SUBJECT: NEW AUTOMATIC STRING ADVANCE FOR ST-40**AFFECTS:** ST-40 (UT-21511-B)

SUBJECT: NEW LEAF BAG A-01068 and LOCKING COLLAR 00909**AFFECTS:** HB-180V (STARTING WITH SERIAL NUMBER HK1210001)
A-00390-D & -E VACUUM KIT

SUBJECT: IMPROVEMENT TO MODEL 340 CHAIN SAWS**AFFECTS:** 340 (UT-10660-C)

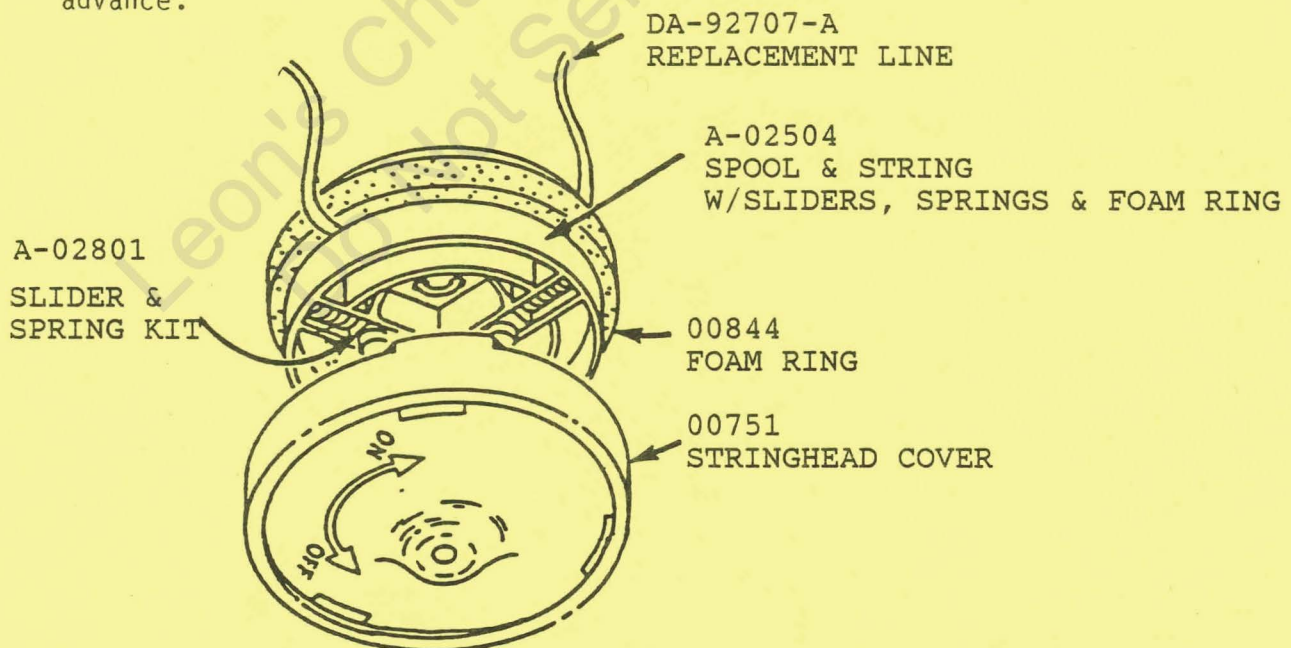
Effective with UT # 21511-B, the model ST-40 string trimmer is equipped with a new automatic string advance system. This is a dual line system incorporating a set of three (3) identical sliders and springs.

The operation of this new system is similar to the previous Idle-Line (TM) system. The difference is the new automatic system may give an advance at full rpm while the trigger is still depressed.

The string head for the new ST-40 is pressed into the motor shaft. These string heads are non-servicable and no attempt should be made to replace them.

Refer to the illustration below when ordering parts for the new string advance.

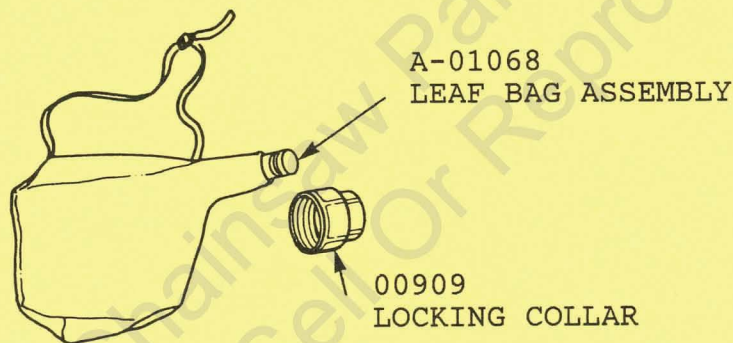
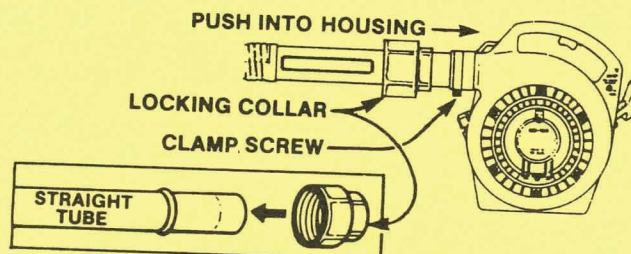
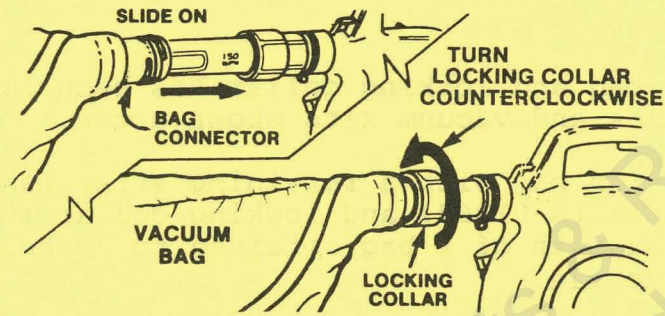
A revised leaf bag and locking collar has been implemented on the subject units and vacuum kits shown above.

The earlier design bag with a retaining strap has been replaced by a bag assembly (A-01068) and locking collar (00909). The bag assembly consists of a bag retained to a short tube section by a large cable tie.

Installation consists of removing the straight tube from the unit. Place the locking collar over the straight tube and reinstall into blower.

Slide the bag assembly over the straight tube and screw the locking collar and bag tube together. Installation is complete.

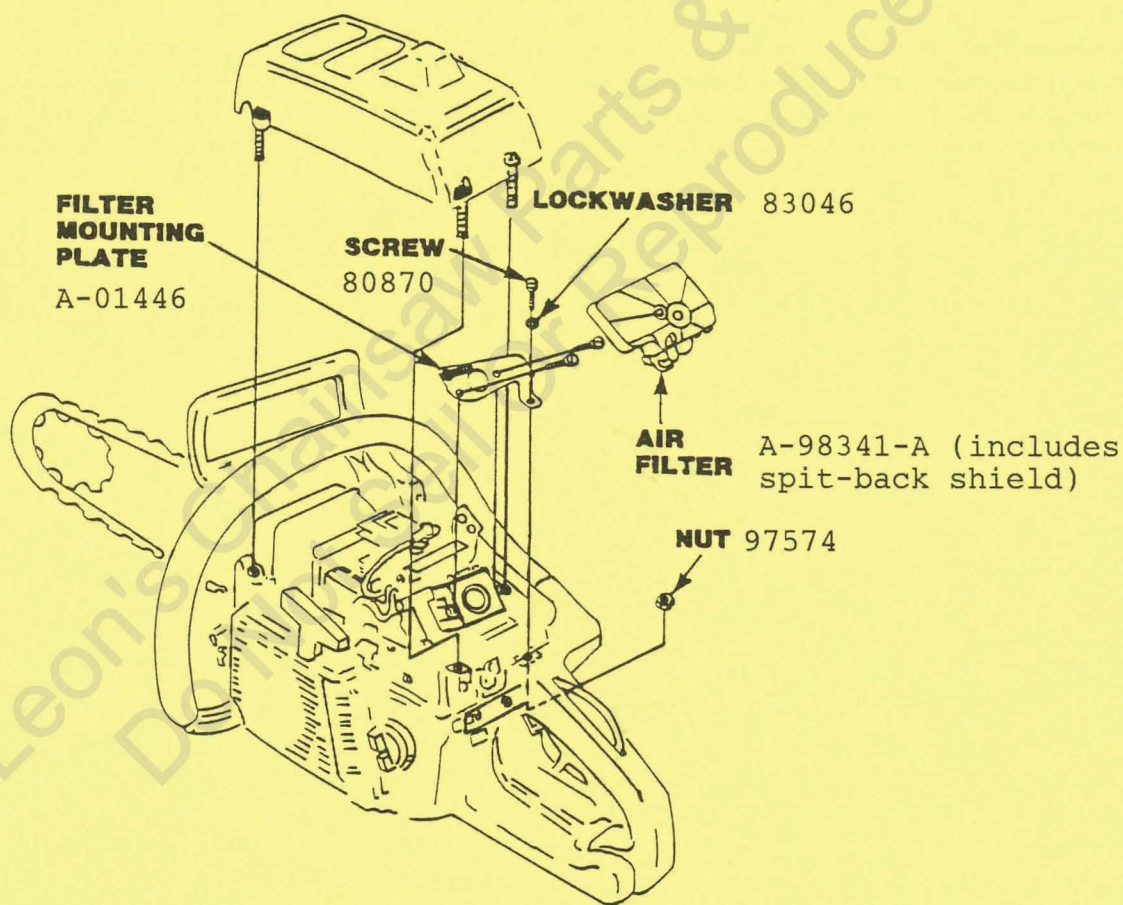
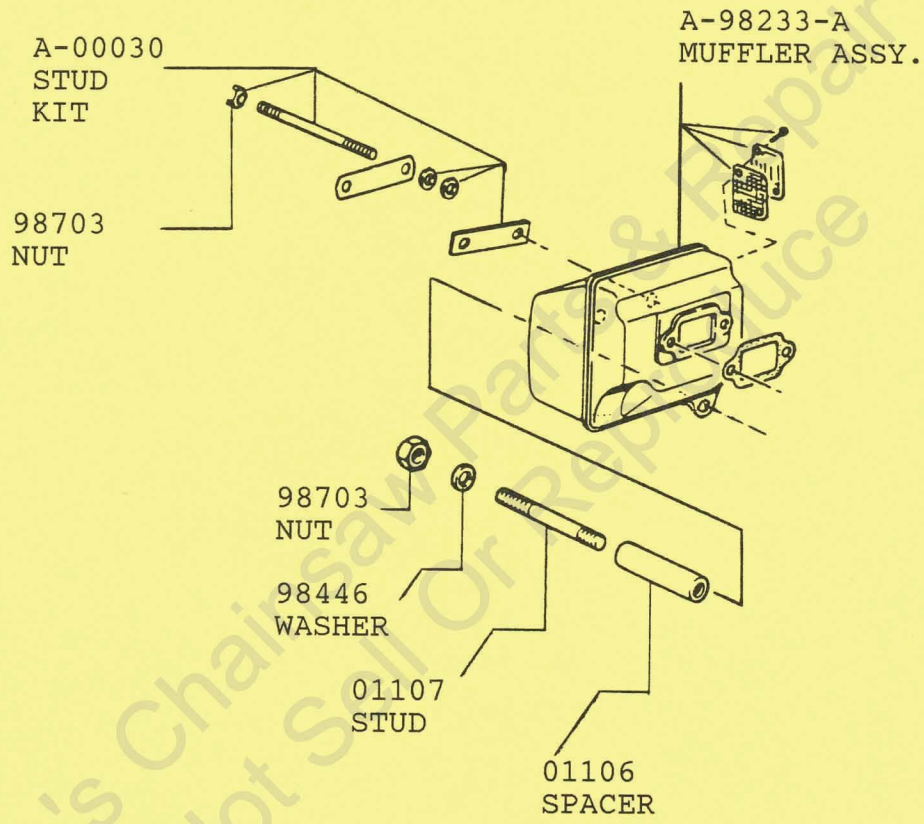
Effective with the subject UT # several improvements have been made to the Model 340 saw particularly in the areas of manifold, carburetor, and muffler retention.

Later 340's were built with the three-point manifold A-01091 which uses an L-bracket 01090 bolted to the cylinder. This required a new baffle A-01089 which incorporates a slot for the bracket. The new manifold will supersede the old manifold (98337-1) and can be used to service units made with or without the L-bracket. The new baffle, however, should only be used on the -C UT # units. Using the new baffle on older units may result in vapor lock. Baffle 98390 will still be available to service older units.

A new three-point filter mounting bracket A-01446 was also implemented effective with the -C UT #. This bracket will prevent the manifold from possible loosening resulting in poor performance and in some cases, piston/cylinder scuffing. Air filter assembly A-98341-A includes a combination choke plate/spit-back shield to prevent the air filter from becoming soaked with fuel mix.

Air filter mounting plate A-01446 can be used on 290 & 340 chain saws and includes fastening parts, a new air filter assembly and installation instructions.

The new three-point muffler assembly A-98233-A will be supplied by service and can be used on units built with either a two-point or three-point mount.

ROTOR
A-95007
USE WITH

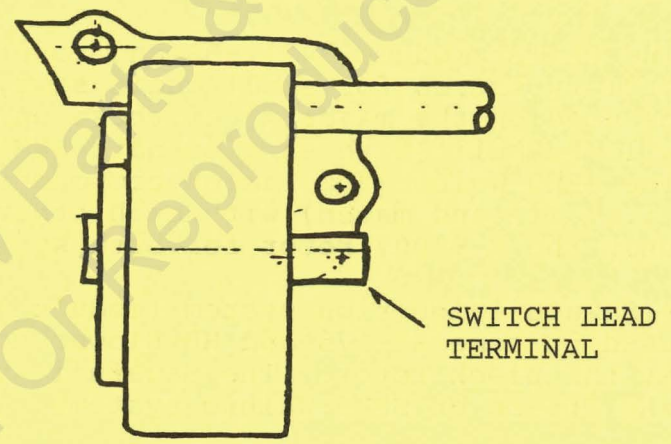
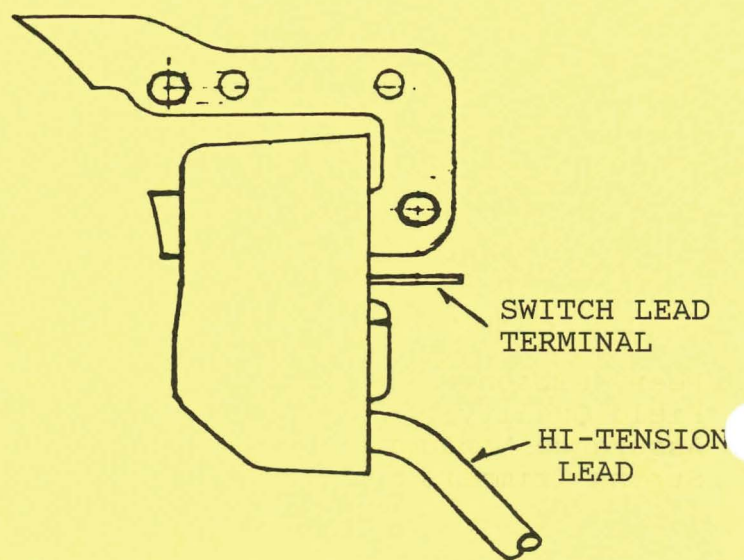
The Phelon module 94711-BS and rotor A-95007 will continue to be the primary source for small chain saws, 25cc trimmers & blowers and will be used on the majority of these units. A percentage of these units will be built with an alternate SEMS-Walbro system (module - 01341). The SEMS-Walbro and Phelon components are completely interchangeable (i.e. mix and match) with each other, therefore, service will supply only the A-95007 rotor for both systems.

A Sawafuji ignition system (module - 02008, rotor - A-02010) will be used on some ST-175 and HB Blower units. This system can be identified by the black rotor. The Sawafuji system is not compatible with either the Phelon or SEMS-Walbro systems.

It is important, therefore, that the ignition system be identified prior to replacing or ordering parts particularly if the unit is a blower or ST-175 trimmer.

ALUMINUM VENTED
TUBE ADAPTER

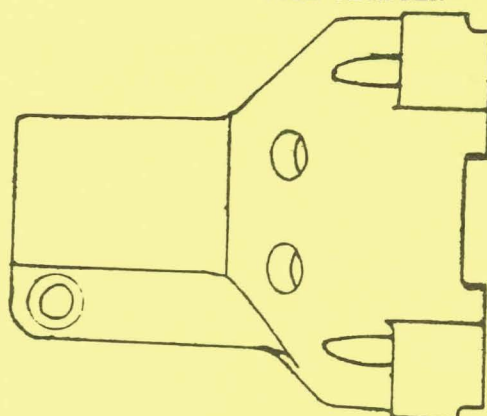
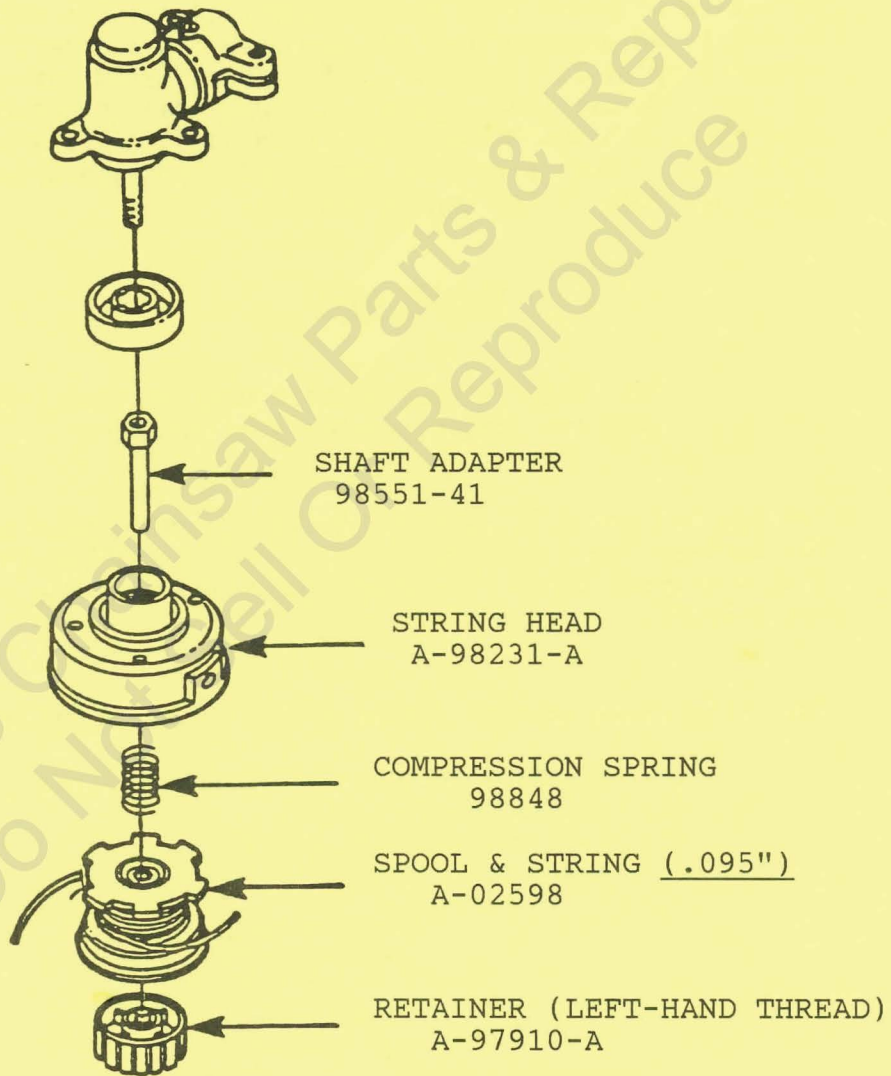
1. Effective with the 1990 build season, all clutch model 25cc string trimmers and brushcutters are equipped with longer, vented tube adapters (plastic - ST175BC, 185, 285 and aluminum - ST385, 485). This will provide air flow through the tube adapter resulting in a cooler running clutch and drum. The clutch adapter was also lengthened by 0.130 in. (3,3mm) providing increased clearance between the rear clutch plate and face of the engine housing.

The longer clutch adapter must be used together with the longer, vented tube adapter.

Service has and will continue to supply only the aluminum tube adapter. The earlier tube adapters A-98931 (red) & A-01139 (black) and the clutch adapter 98930 have been superseded to a new vented tube adapter kit A-02396.

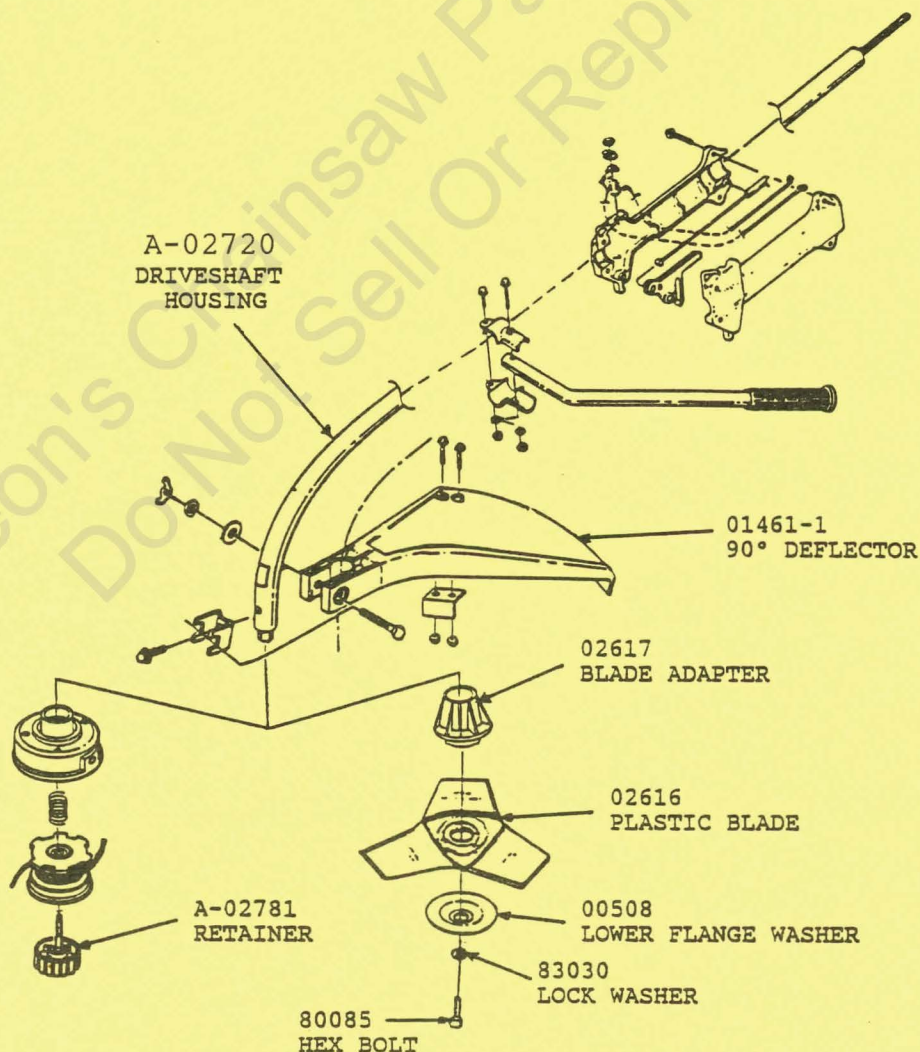
3. The Model ST-175C has been replaced with the Model ST-175BC (UT-20553B). This unit is equipped with a string head assembly and a plastic tri-arc blade designed for cutting heavy grass only. The blade adapter is also designed such that a metal blade cannot be installed on the unit.

The ST-175BC is designed to accept the plastic tri-arc blade only. Any modification made by the customer or the dealer to accept a metal blade may result in damage to the unit, particularly the lower drive housing assembly.

The unit is also equipped with a 90° deflector, L-handle and toggle switch in the rear handle grip.

Refer to the illustration below for the parts which are unique to the ST-175-BC (UT-20553-B). Otherwise refer to the Parts List 17968-B.

Figure 1

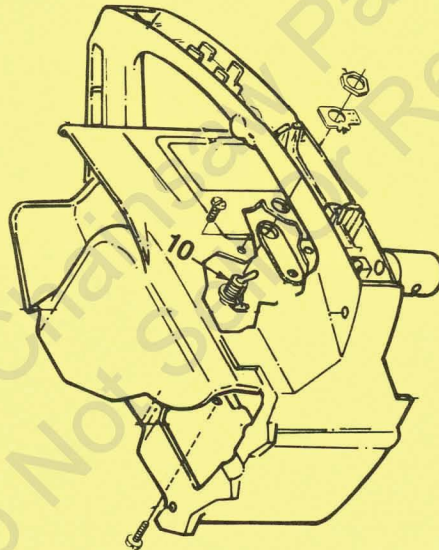
The switch and lead listed in Parts List # 17868 is incorrect. Part number A-94721 is a lead only used on the S/2 with the aluminum engine housing. When ordering the switch for the unit with the plastic housing you will have to order the lead separately.

Item #10 Old Number A-94721 Switch & Lead New Number 93653 Switch

Item #11 A-94721 Ground Lead - to be used with 93653 Switch

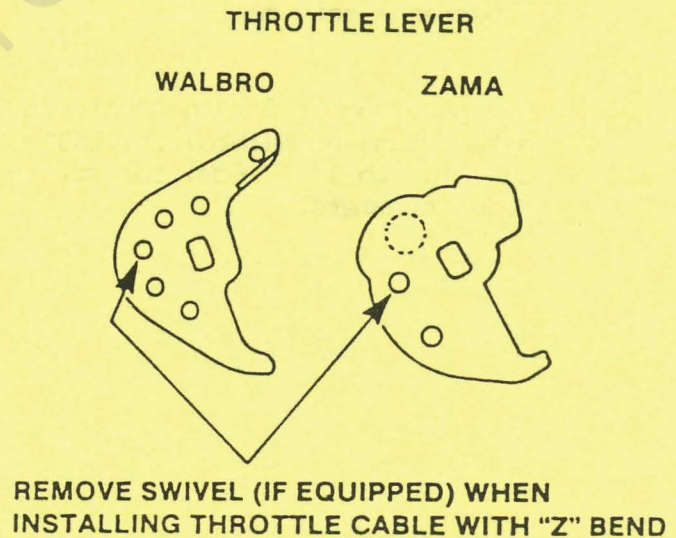
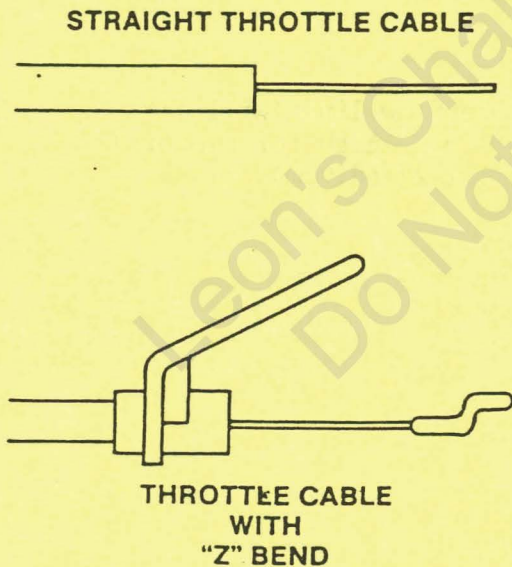
1. Several field complaints have been received recently concerning fuel leakage through the carburetor on string trimmers and blowers. The problem has been traced to the check valves in the primer base. Once the fuel tank is pressurized, the check valves start to leak. Fuel is pushed back into the metering chamber and out the main nozzle.

Field fix- install fitting 01327 and duck bill valve 98819 on the end of the primer overflow line (inside the fuel tank).

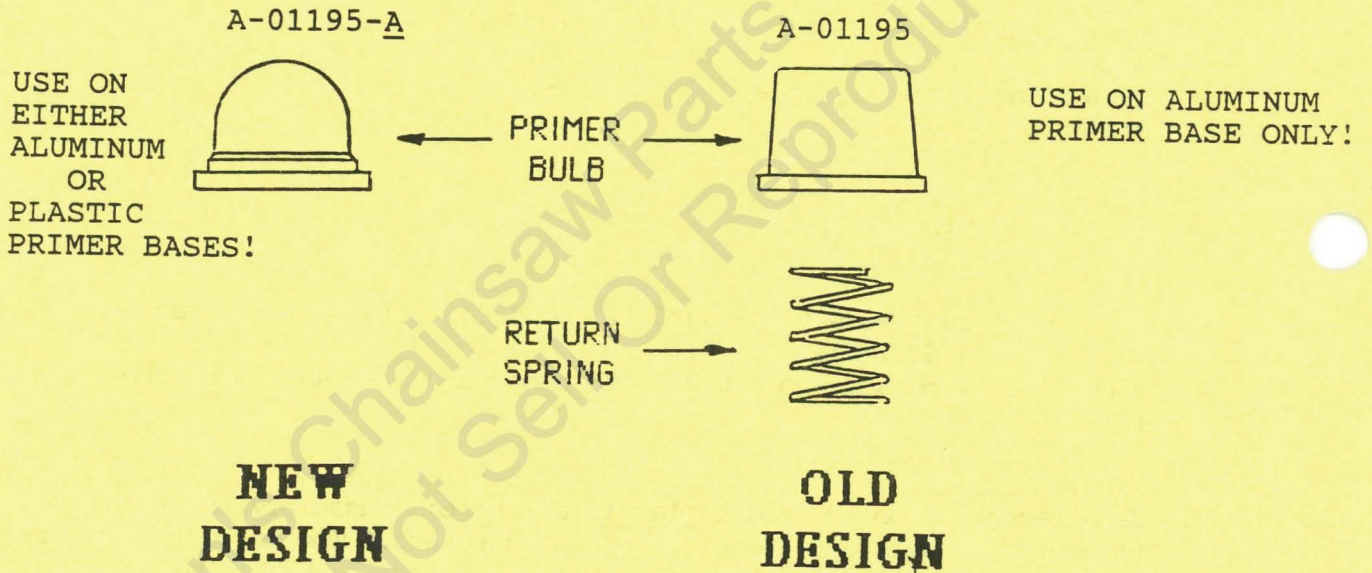
4. The Zama primer bulb was recently revised (see diagram below) and the spring removed. The earlier, flat top primer bulb with spring will only fit on aluminum primer bases. The new dome shape bulb will fit either the aluminum or plastic primer bases.
